REQUEST FOR ADDITIONAL INFORMATION

MARK I CONTAINMENT LONG TERM PROGRAM

PLANT UNIQUE ANALYSIS REPORT

BRUNSWICK STEAM ELECTRIC PLANT

SHEET 50 OF 187

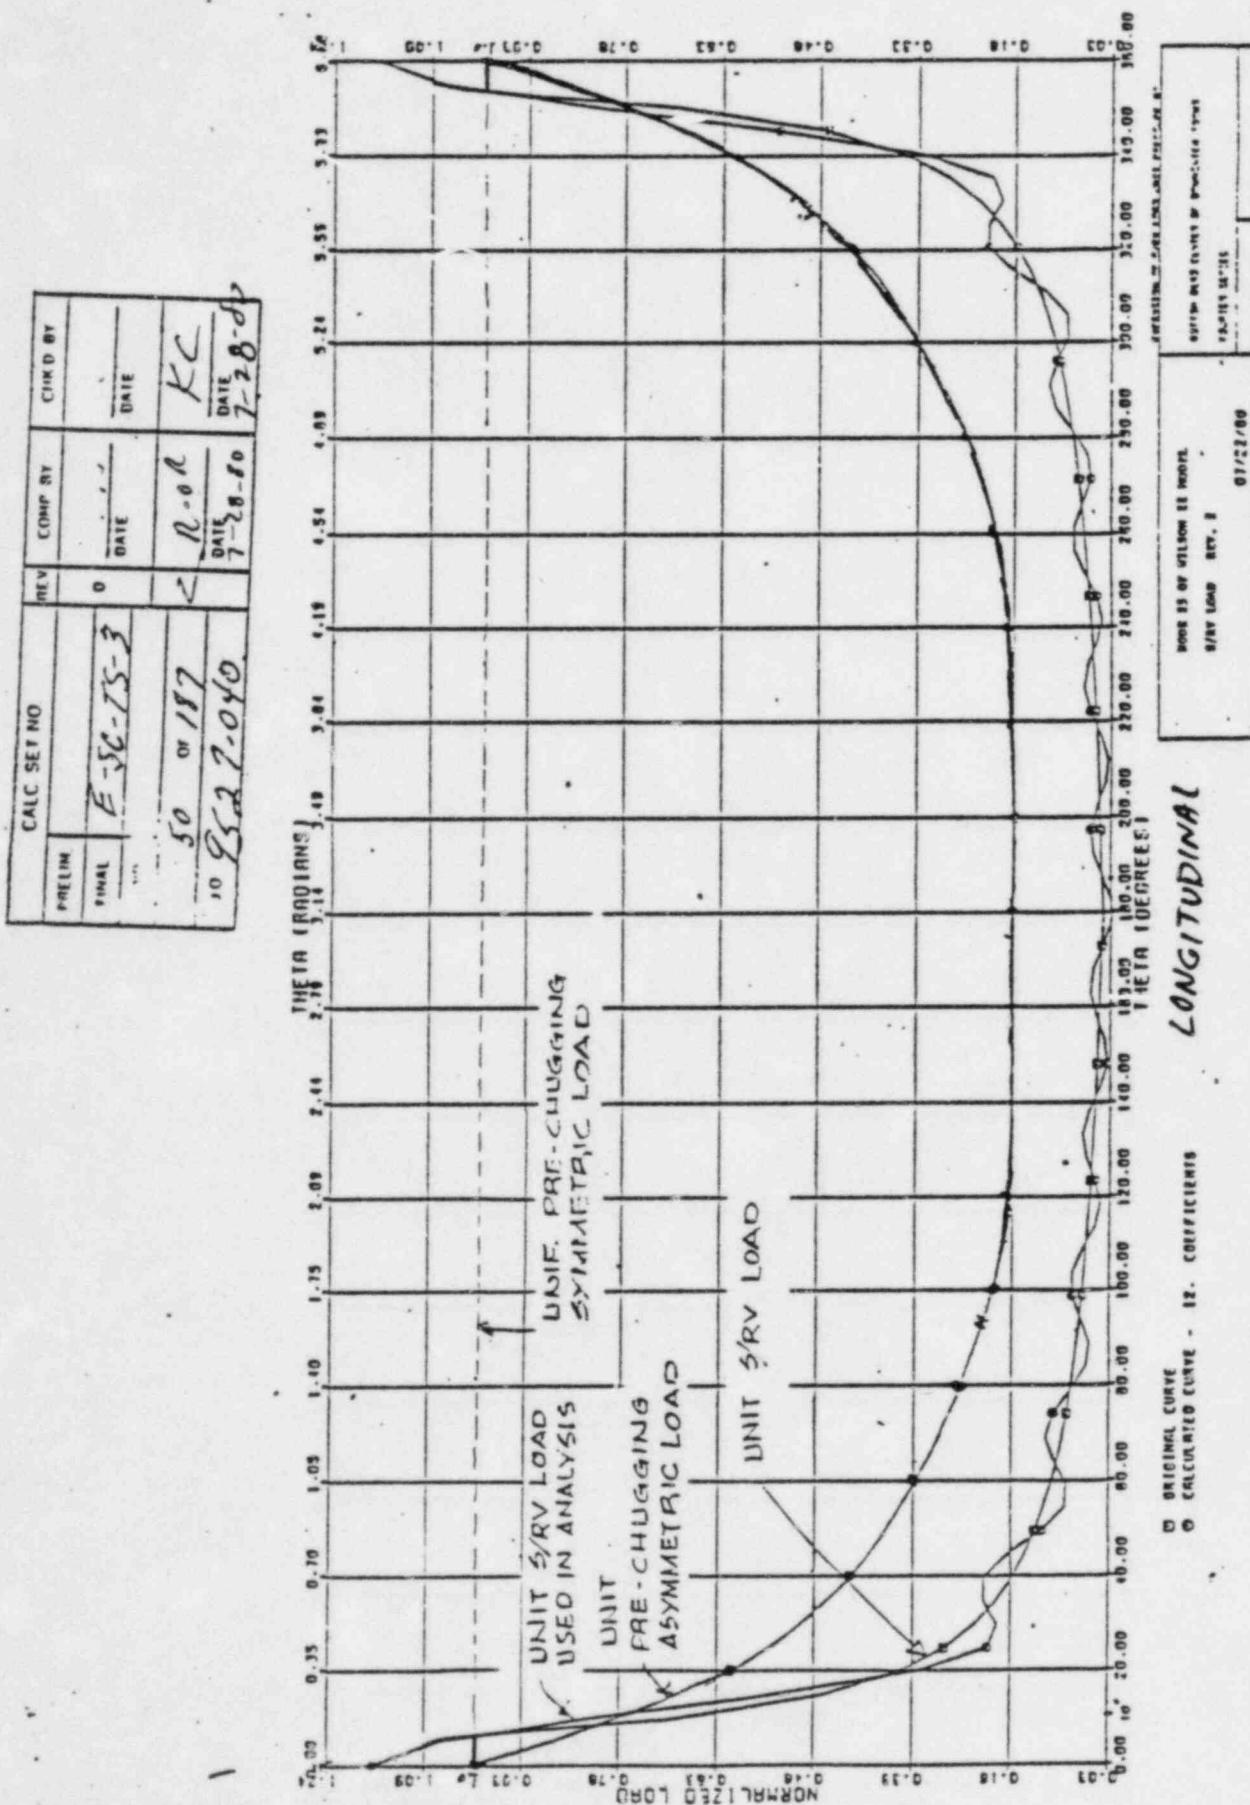
Provide a comparison of the longitudinal distributions for both the unit S/RV and pre-chugging loads and discuss any available conservatisms which may offset the differences between the two distributions.

Calculation sheet 50 of 187, Attachment RAI 1b, shows the longitudinal distribution of the:

Fig. 1 Pool Small Displacement Distribution

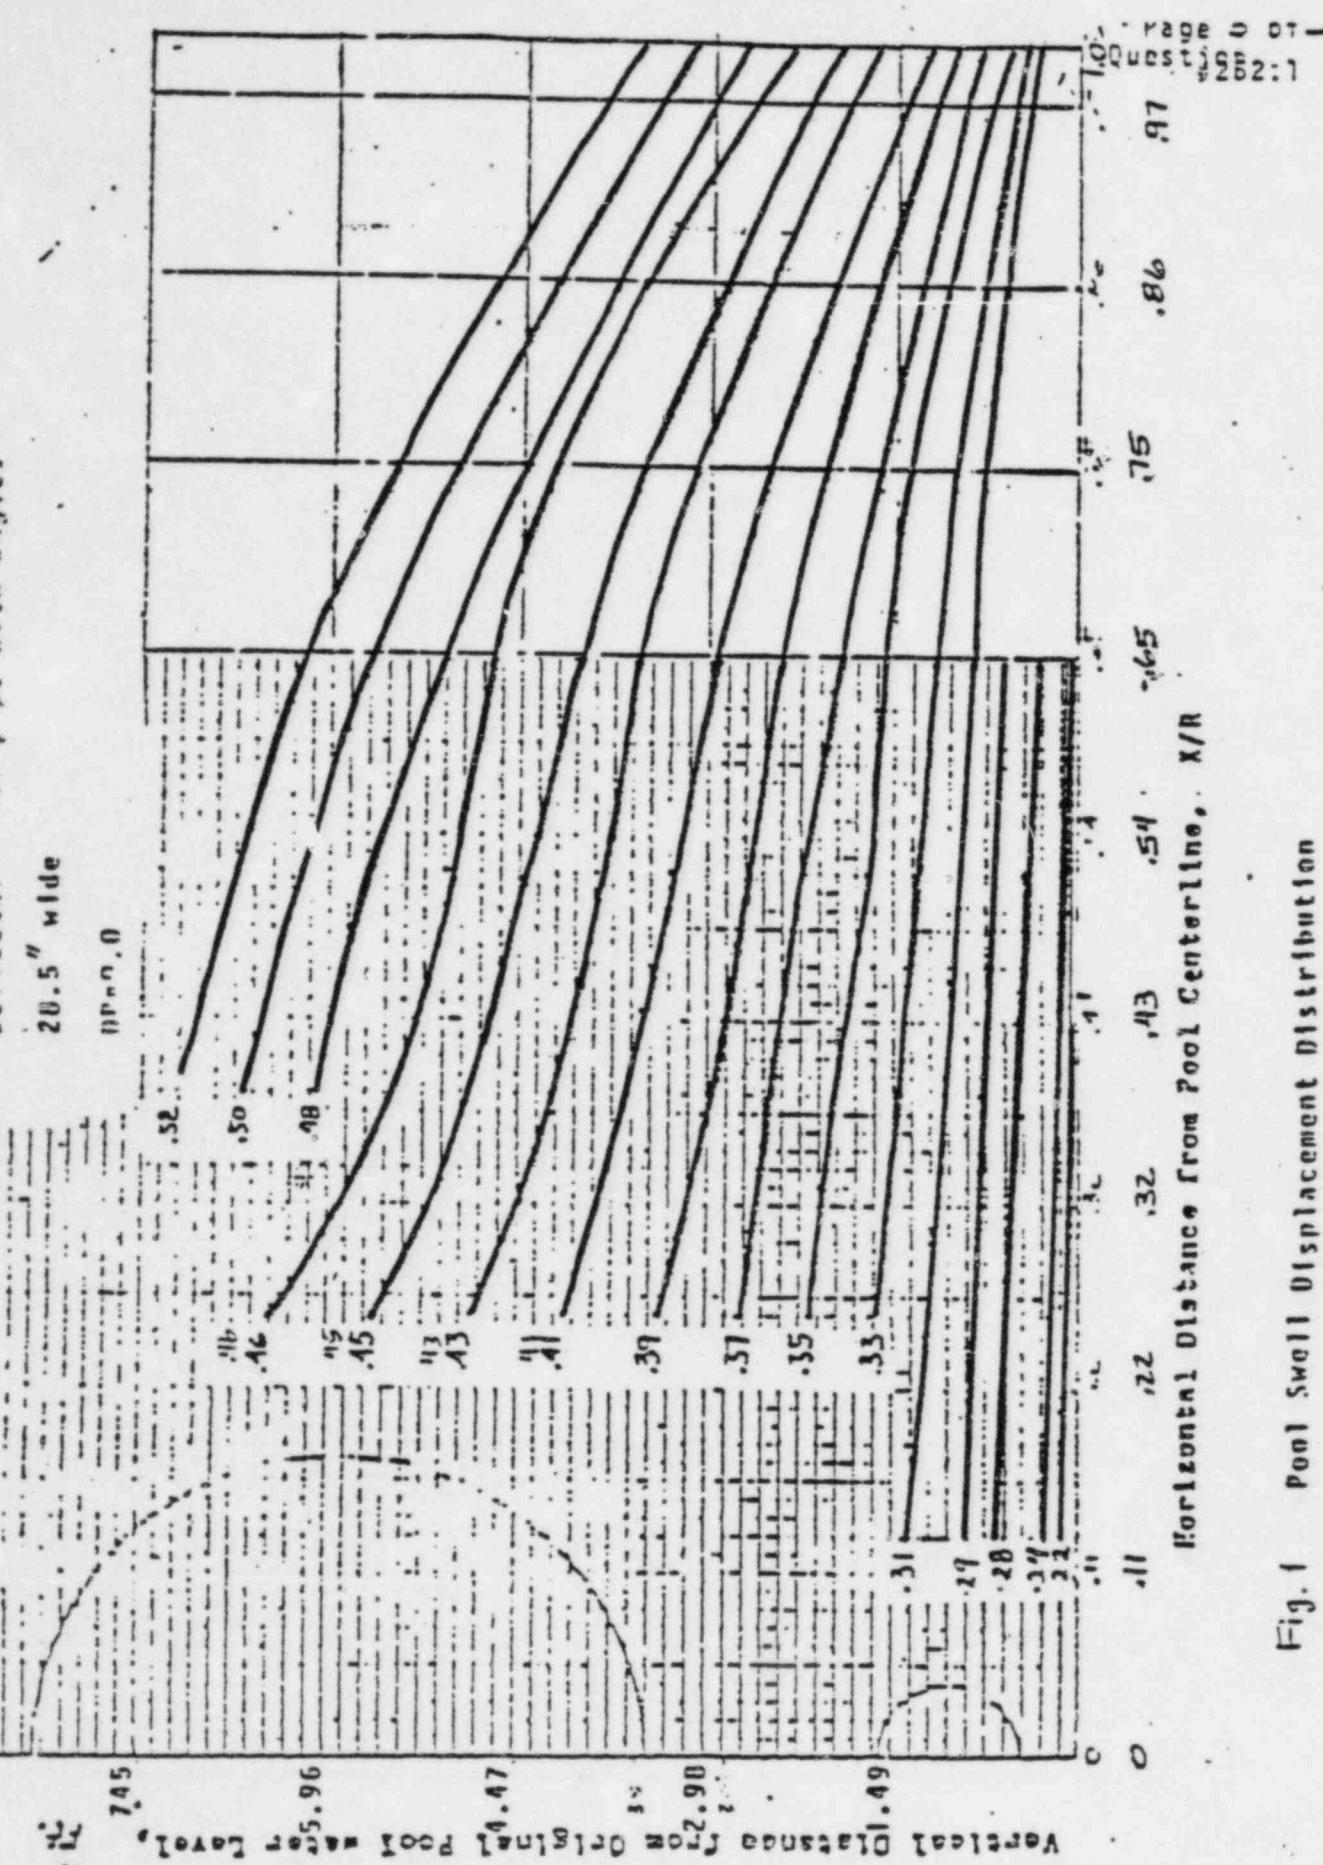
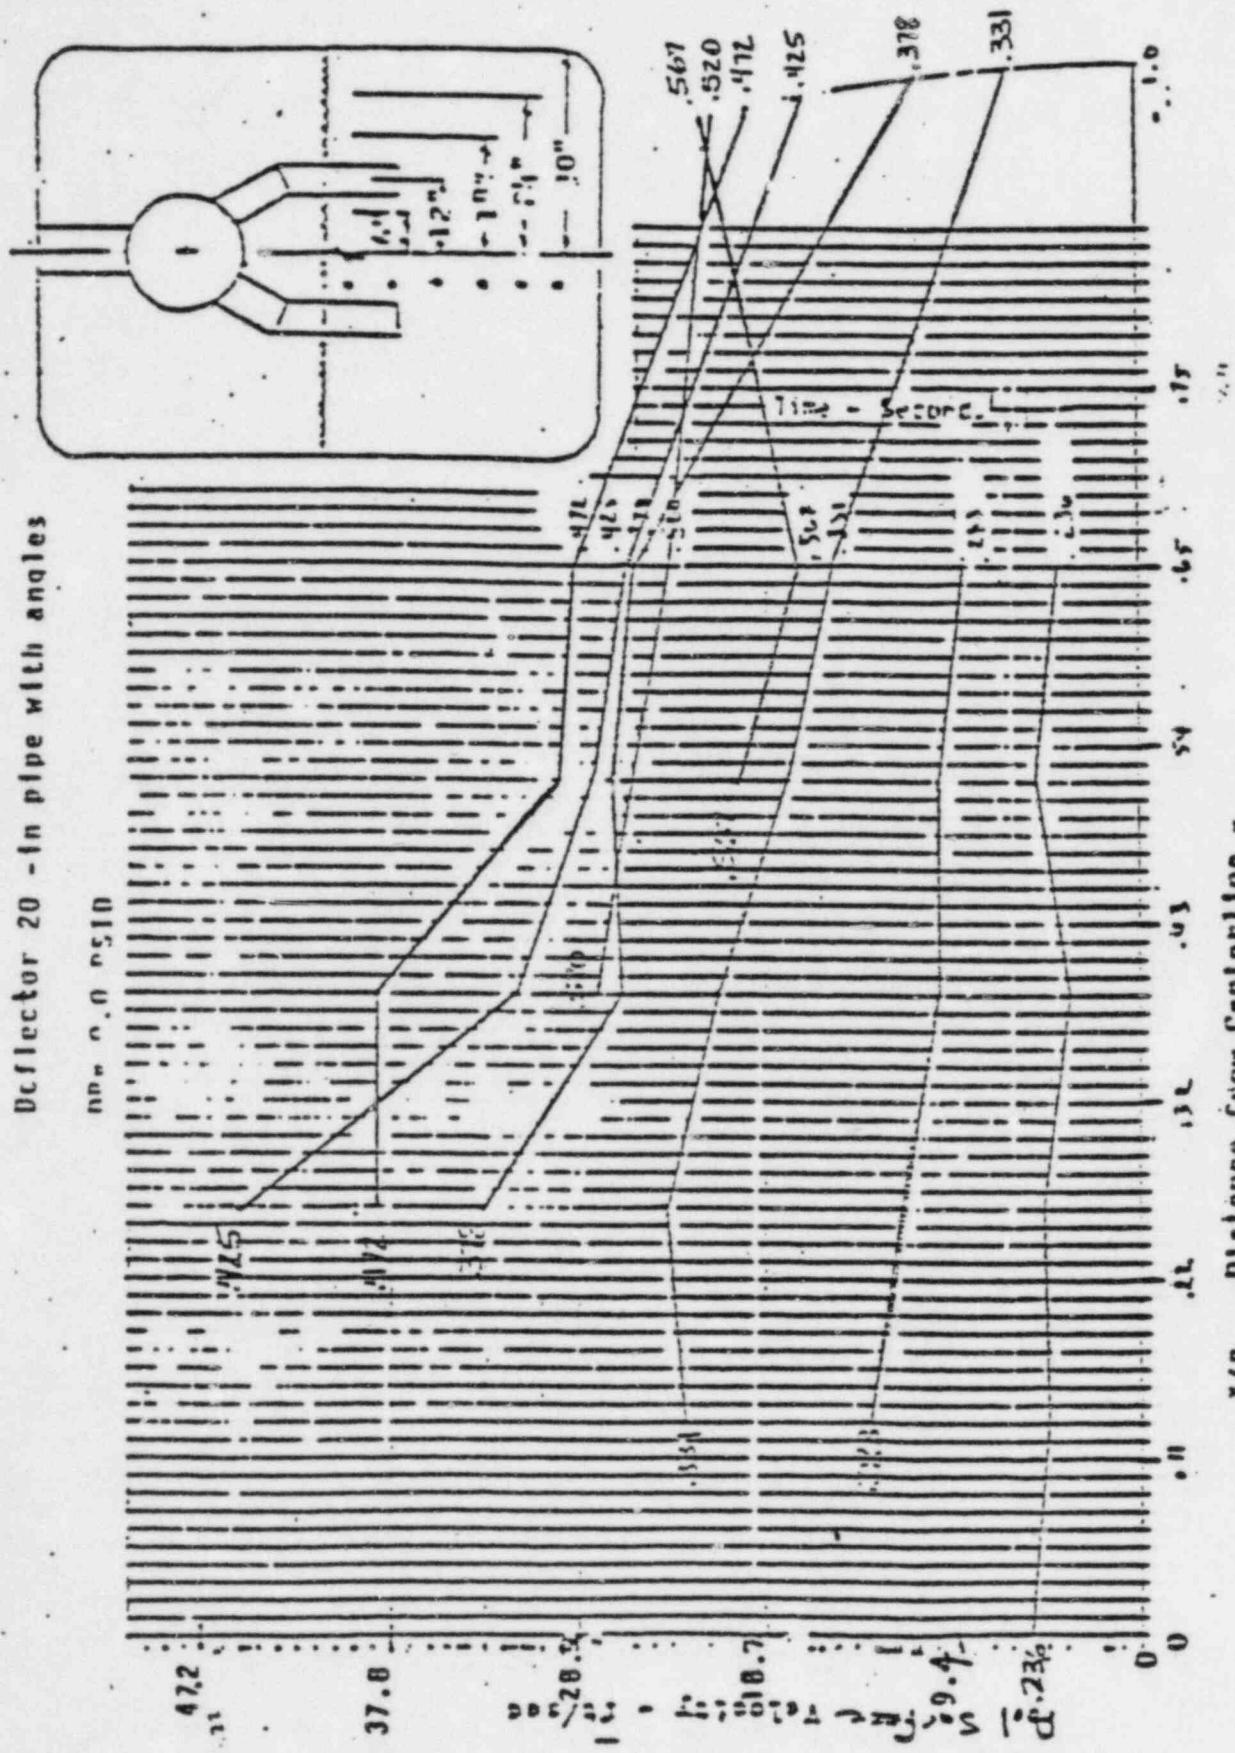
Provide all pertinent documentation on the method used to develop the load definition for Brunswick from the Monticello test results and indicate why these pool swell profiles are a conservative representation for the Brunswick geometry.

Figures 1 and 2, Attachment RAI 2b-1, were the pertinent documents utilized to develop the load definition for Brunswick from the Monticello test results. The use of the Brunswick pool swell profiles is conservative and is justified by the General Electric Company's "MARK I SSE Question Response", Attachment RAI 2b-1. GE's justification did not include the effects of modified downcomer submergence which is 1 ft. shorter than the original submergence on which the QSTF test and load specification were based.

Attachment RAI 2c-1

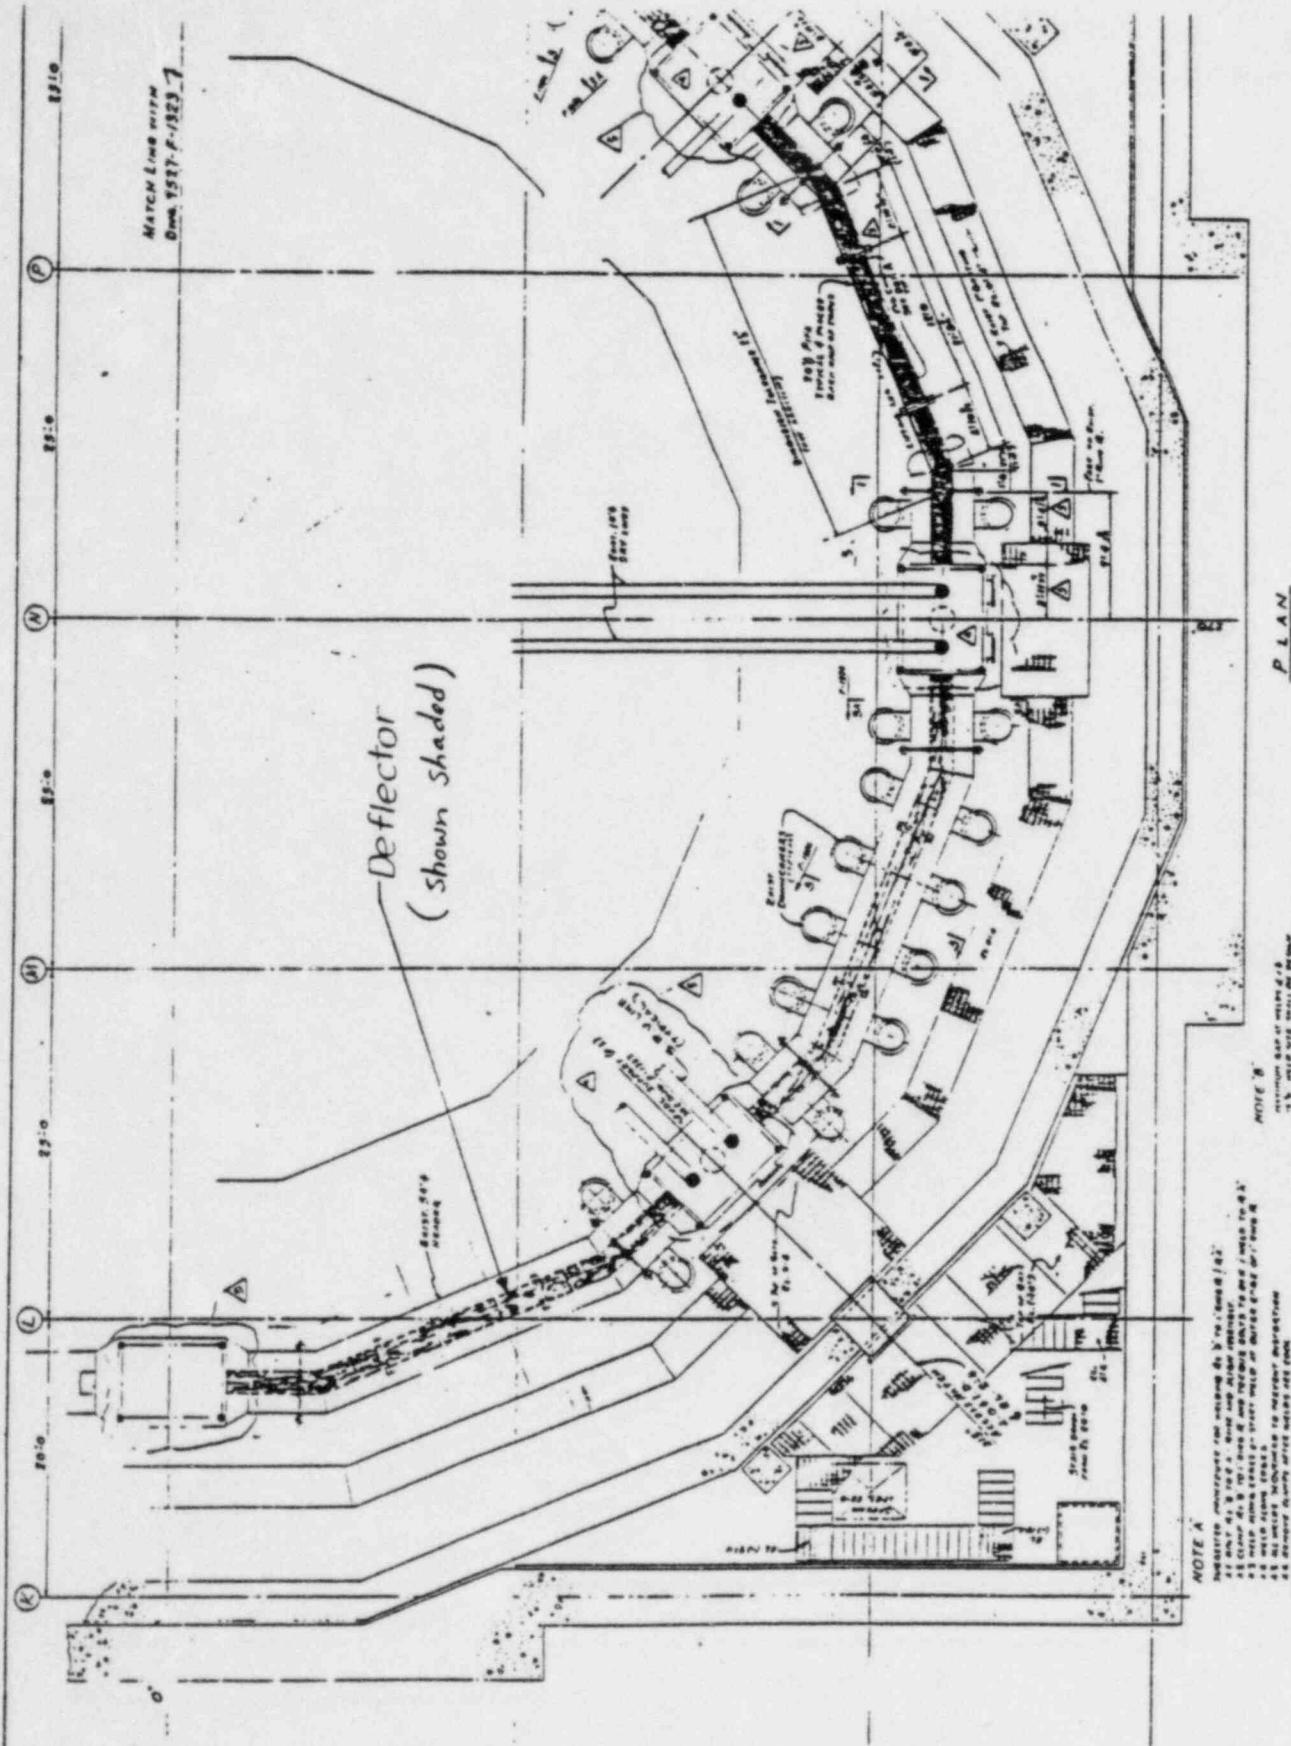
RAI 2c - PUAR Section 2.2.1.2, AC Section 2.7

When calculating pool swell loads, the first set of curves were used for structures located in the region without the deflector while the second set of curves were used for structures located in the region with the winged deflector. Figure 3, Attachment RAI 2c-1 shows the regions in which different pool swell profiles were applied. Both Brunswick and Monticello pool profiles were derived from OSTF tests with deflectors. The former was specifically tested for the Brunswick plants. There is no test data available for pool swell without deflector. For regions where no deflector exists, Brunswick pool profiles were used since they are closer to the actual plant geometry than those based on the Monticello test. The use of the Brunswick pool swell profiles is conservative and is justified by the General Electric Company's MARK I SSE Question Response", Attachment RAI 2c-2.

Figure 114.1-2 - Recommended Extrapolation of Pool Swell Displacement Profiles

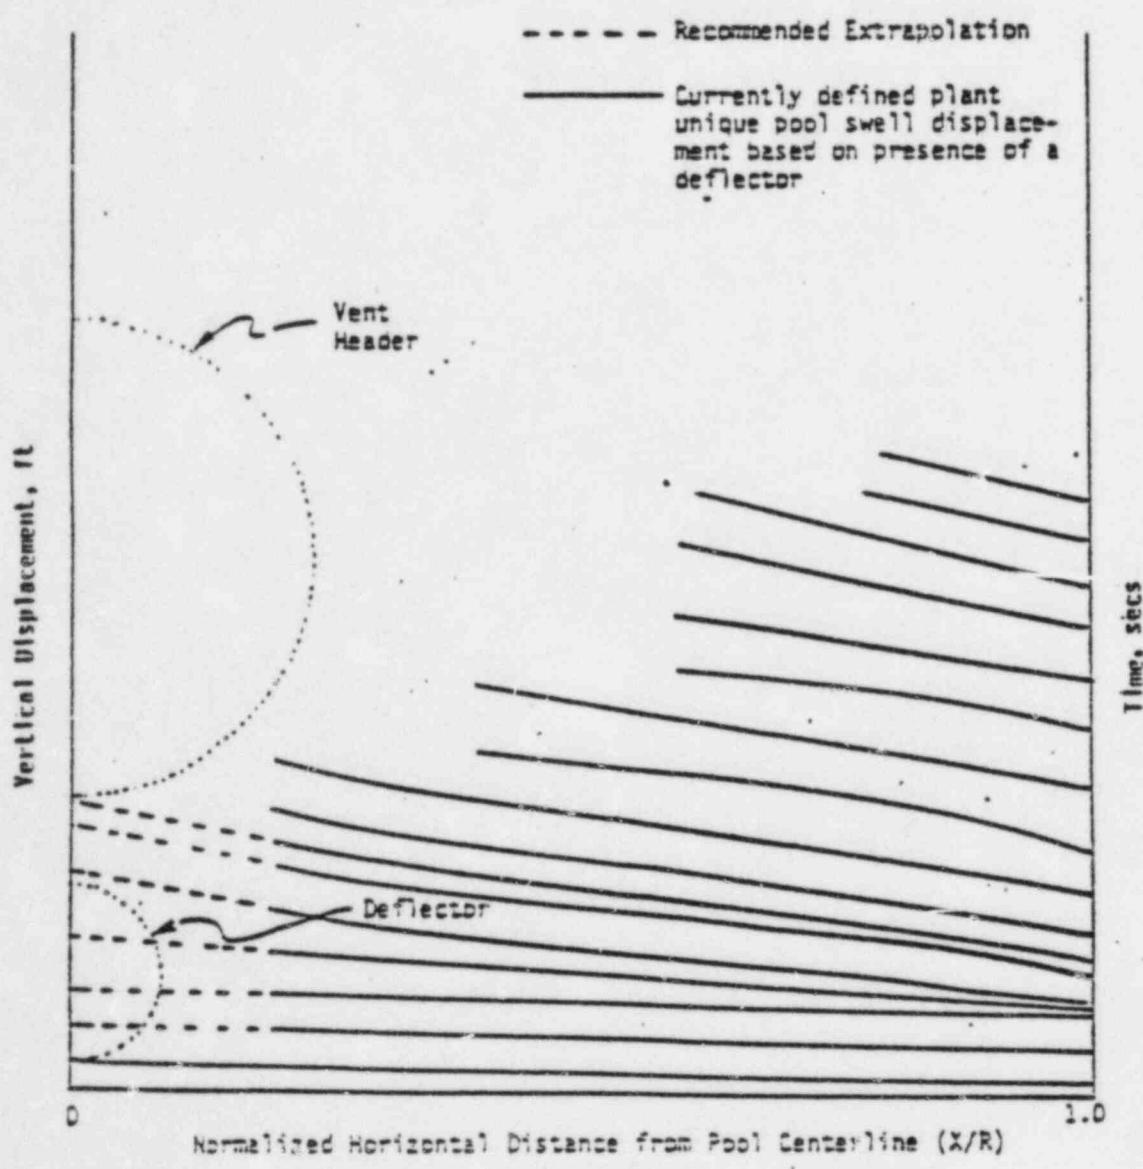
Carolina Power & Light Company is currently planning to install the vent header deflector in only the non-vent bay. Our 1/4 scale tests were conducted with the vent deflector, and thus our plant unique load definition for pool swell is with the vent deflector. This letter is to request that General Electric provide a load definition for pool swell without a deflector for our use in the analysis of the vent-bay. This subject has been discussed previously between United Engineers and Constructors (Mr. H.E. Painter) and General Electric (Mr. S.W. Smith).

- a) Pool swell displacement - Extrapolate the plant unique pool swell displacement profiles directly above the vent bays to a value equal to zero. A sketch demonstrating this recommended extrapolation is presented in Figure 114.1-2.
